# Memorandum

Subject: 2212 Rivermont Avenue Staff Finding

APPLICATION FOR CERTIFICATE OF APPROPRIATENESS (COA)

Typical Rail Detail

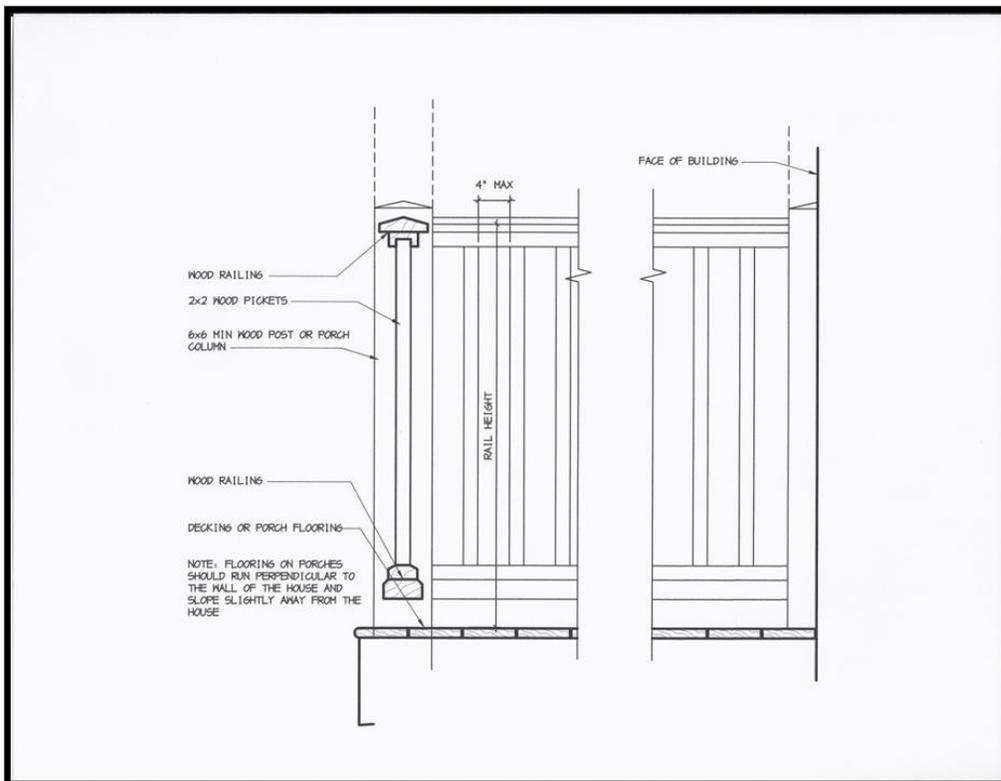
The Residential Historic District Design Guidelines are unclear on what railing is appropriate on a Georgian Revival Dwelling. A similar railing treatment is found on 1411 Madison Street.
